Fort Street Public School / Architectural Design Statement  
Section 4.55 Modification 2- Minor Amendments

Department of Education [SSDA 10340-Mod 2] — REV 06 —11/11/2022

Upper Fort Street, Observatory Hill, Sydney

/ Comparison views  
View from the east

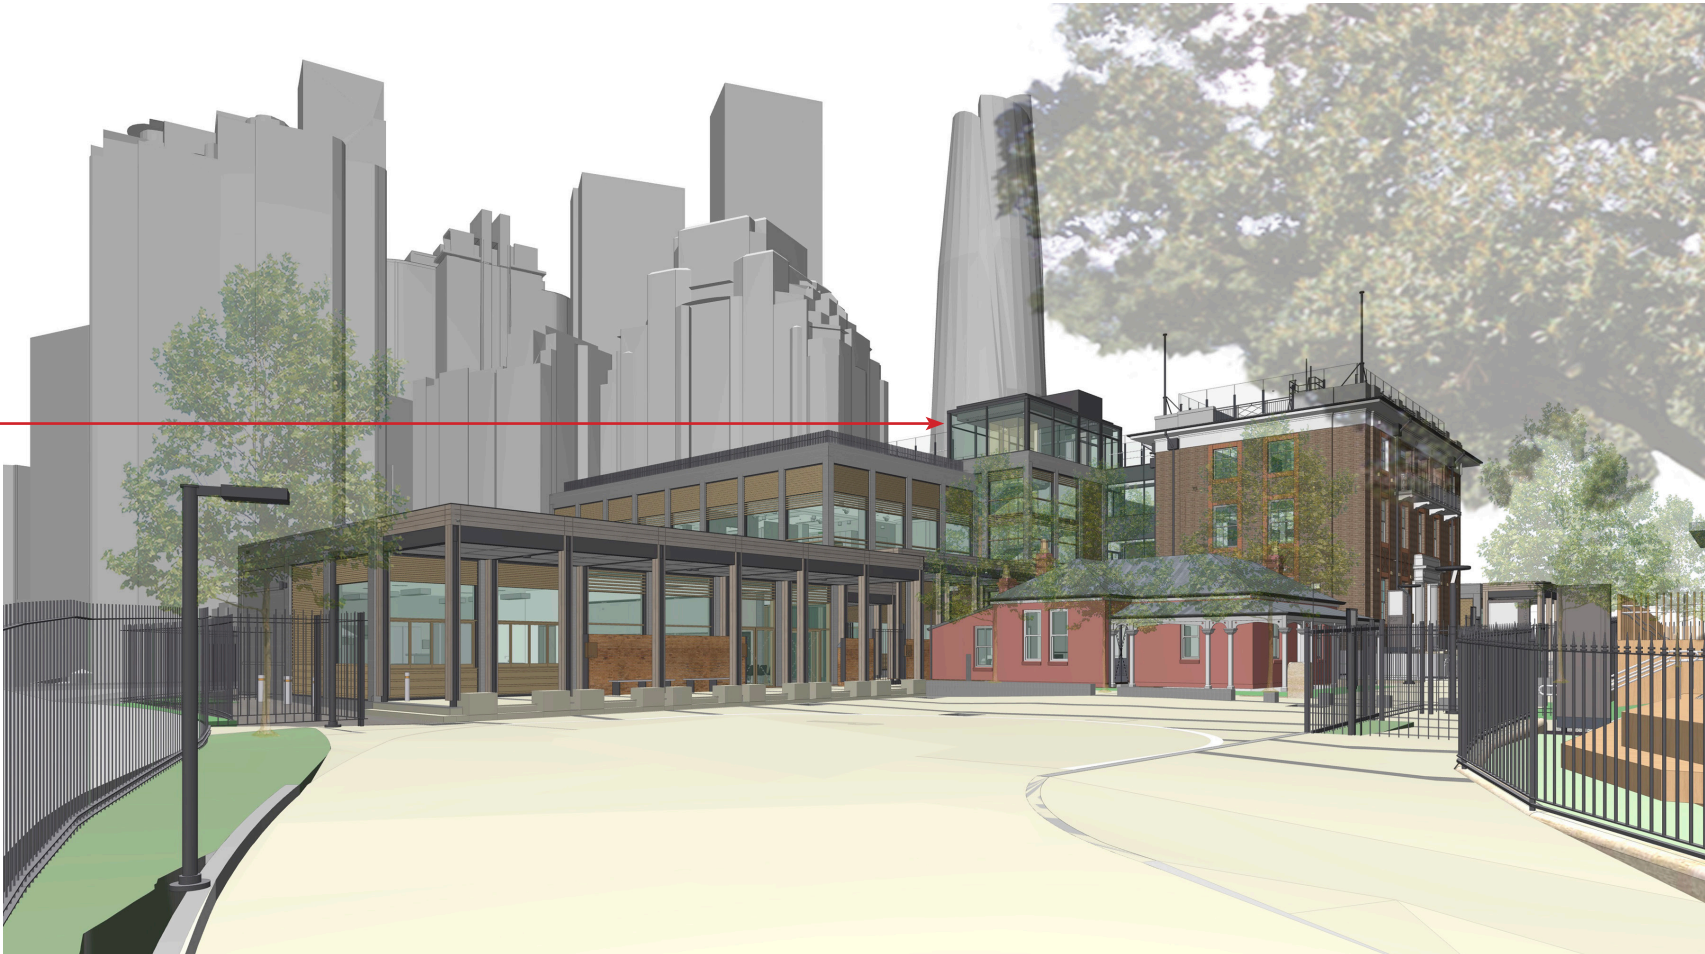
Lift shaft and Stair Lobby raised  
(610 and 310mm respectively)

View from the west

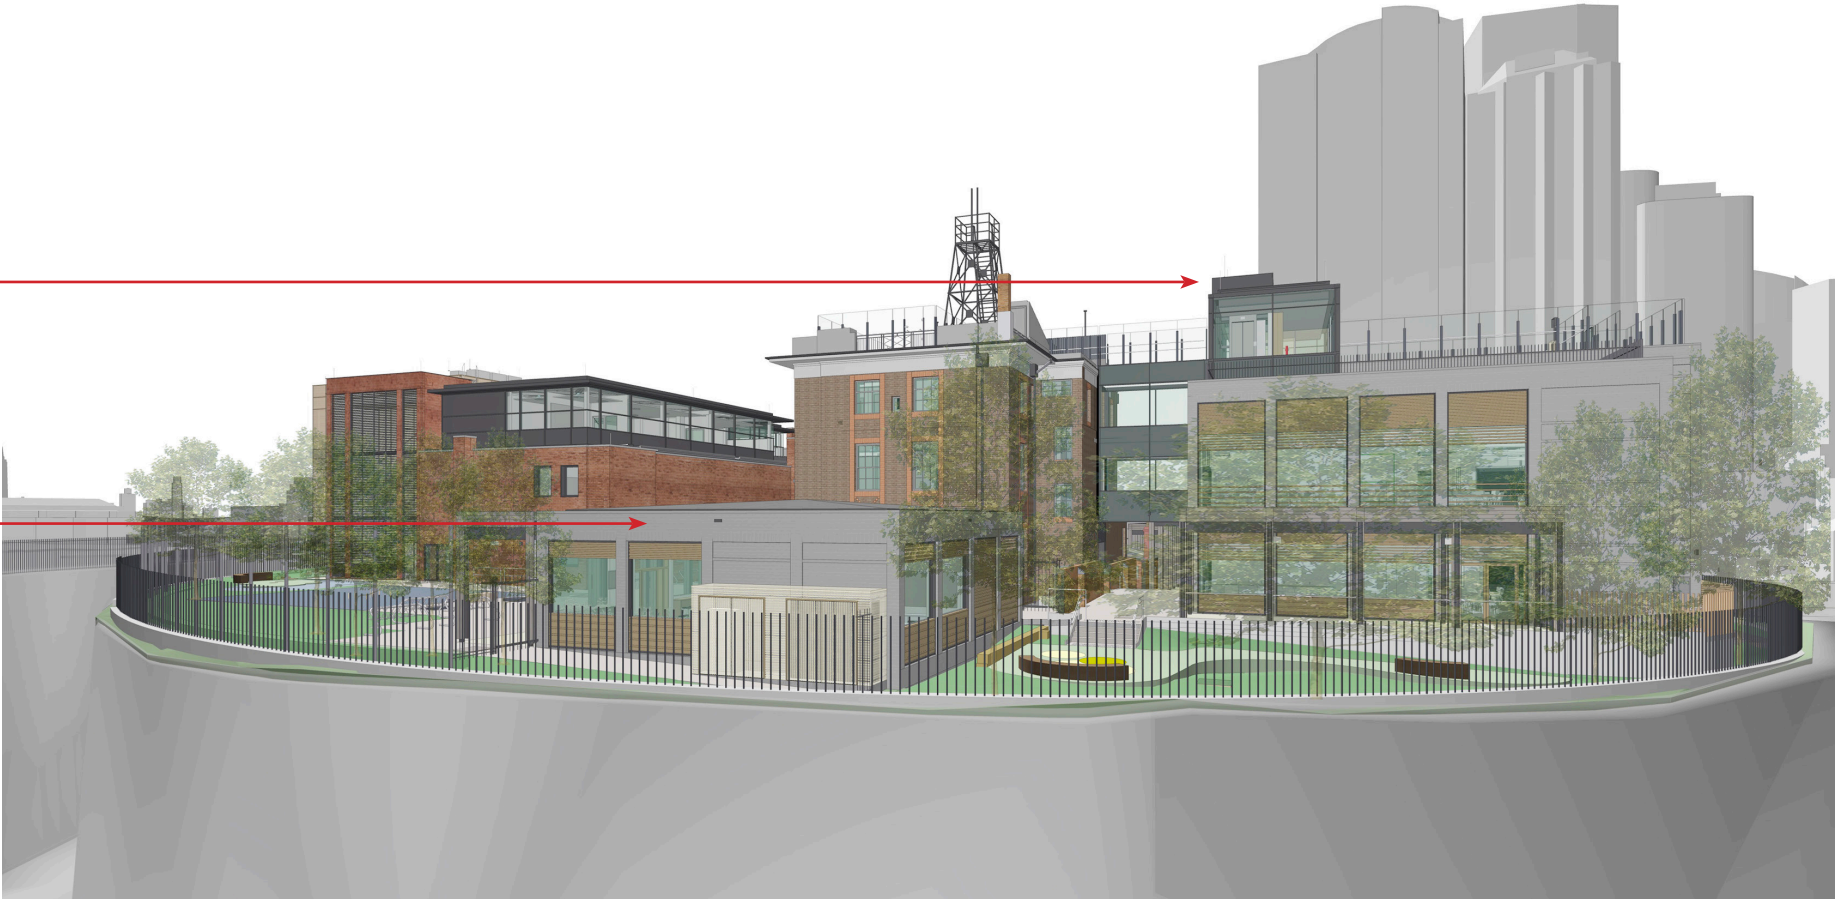
Lift shaft and Stair Lobby raised  
(610 and 310mm respectively)

Building F lowered

View from the south (National Trust)

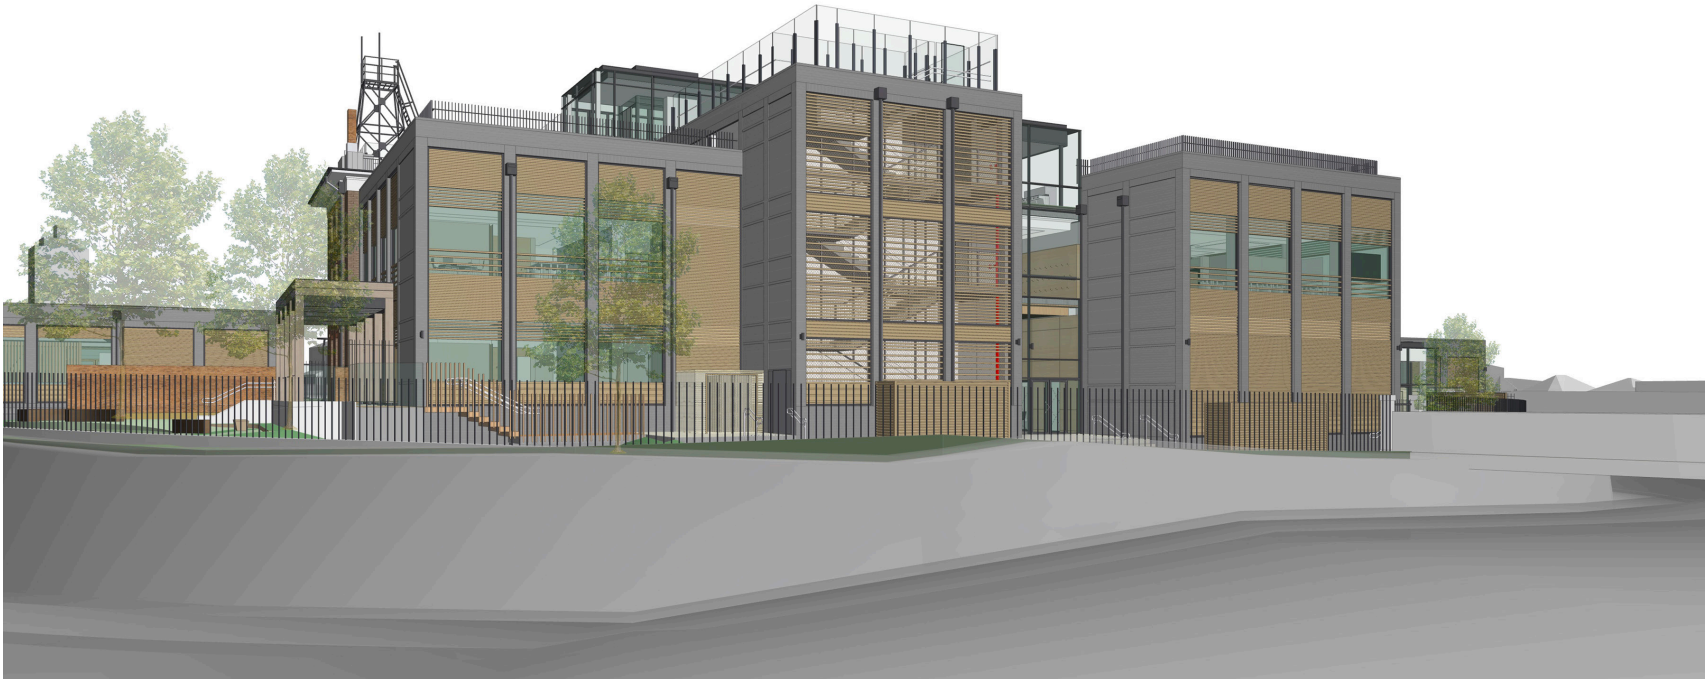
Lift shaft and Stair Lobby raised  
(610 and 310mm respectively)

Building F lowered
